Addendum #6

October 7, 2025 (13:29:25 EST)
K:\0186685\000_DAG_GCSC NURSING AND SIMULATION CENTER_Civil\DWG\DEMOS\PRODUCTION\186685_DEMOPLAN.DWG C-101 DEMO & EROSION CONTROL PLAN BY: MURST

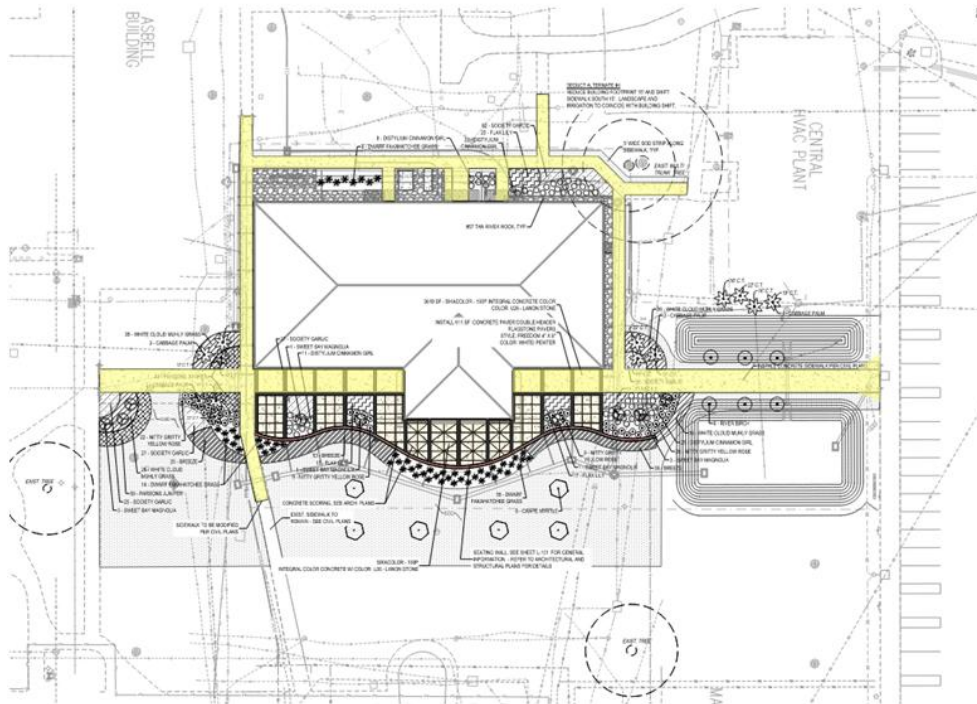
-Detail 5 on I-202 shows a 1/2"x1/2" square tube with keyholes to attached a 1-1/2" wide plywood branch to. Is that tube to be steel and is the size correct? (See answer below...)

Detail 5 on I-202 shows a 1/2"x1/2" square tube with keyholes to attached a 1-1/2" wide plywood branch to. Is that tube to be steel and is the size correct?

Response: The square tube shall be steel; final design comments can occur during the submittal process.

C-102

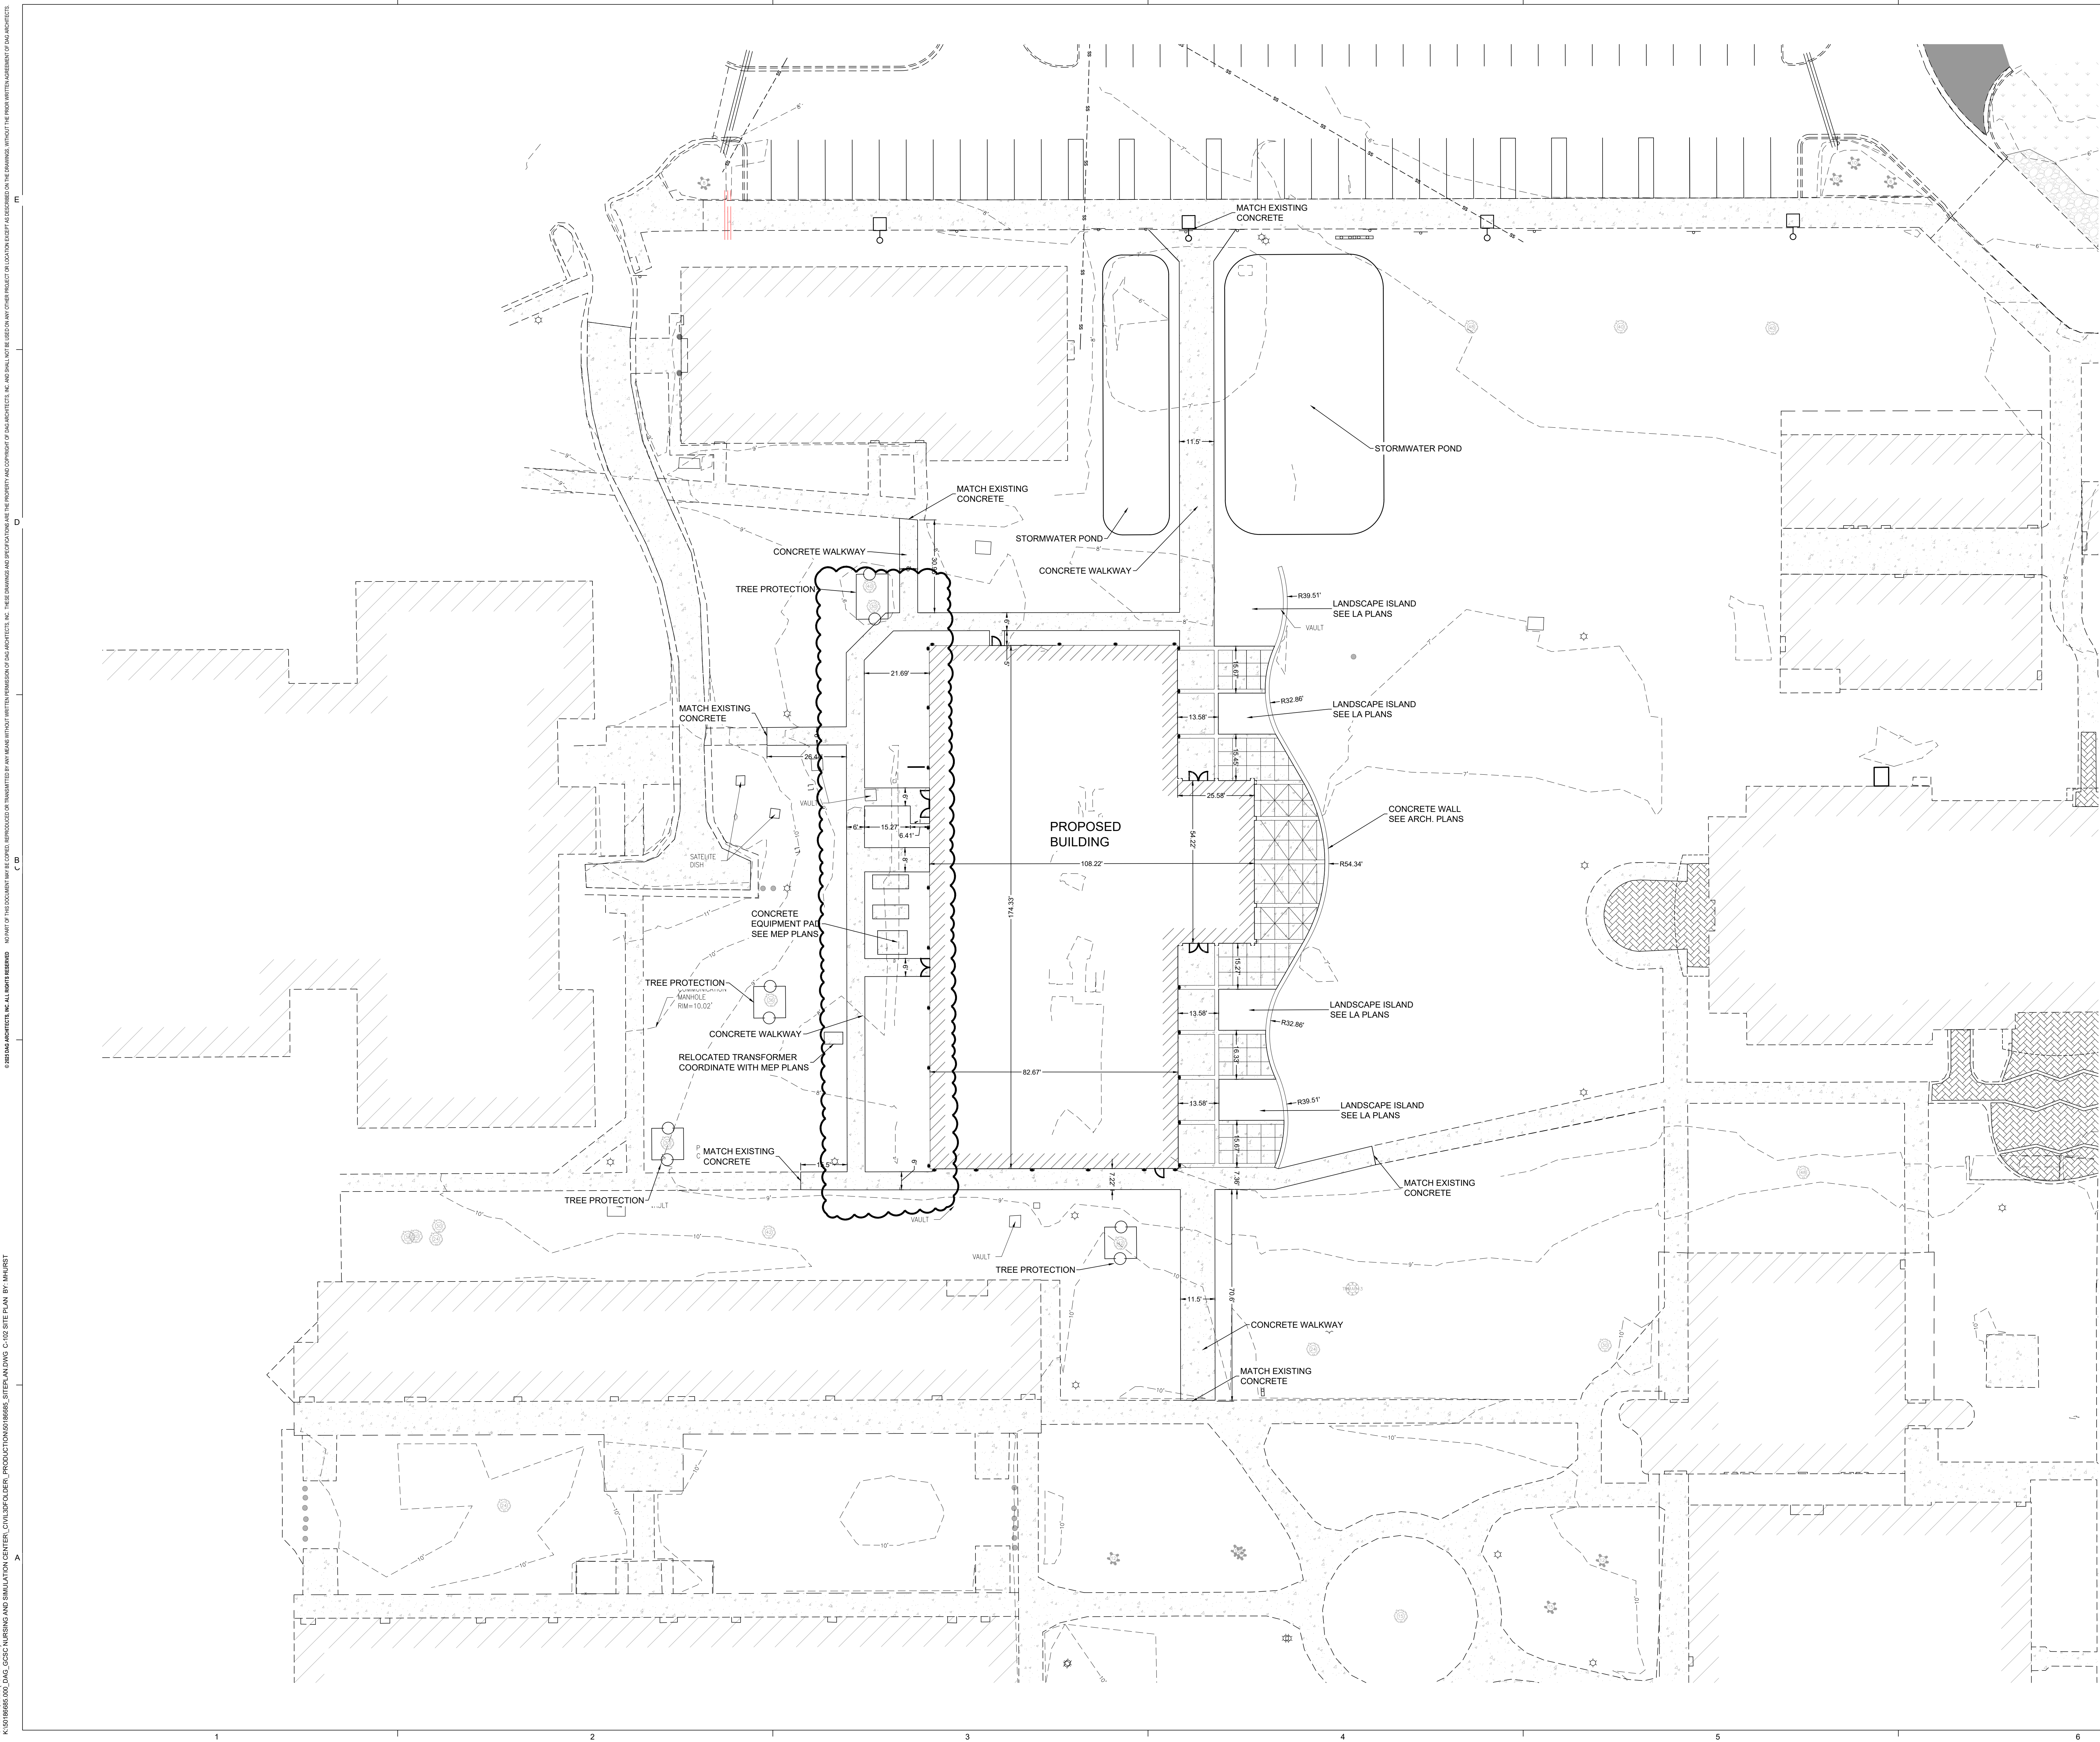
- Is there a detail for the 3 concrete equipment pads on page C-102? They are on the West side of the building. **RESPONSE:** Refer to detail 2/M-202 for information.
- On the East side of the building (right next to the DS-7 Inlet), there appears to be a missing roof drain. There is an Inline Drain shown as well as pipe running over to the 18" ADS. However, a roof drain is not shown. Please advise. **RESPONSE:** That drain line serves only a floor drain in the patio, no downspouts.
- Page C-104 shows a 4" GV on the 6 WM before it goes into the building. Should this be a 6" GV? **RESPONSE:** Yes, that should be a 6" GV on the 6" WM.
- In addendum #2 on page three under 1A-# Drawings question #3 - I do not believe the survey was attached. Can the survey please be provided? **RESPONSE:** The most current survey was incorporated into the Civil drawings, so that comment needs to be redacted.
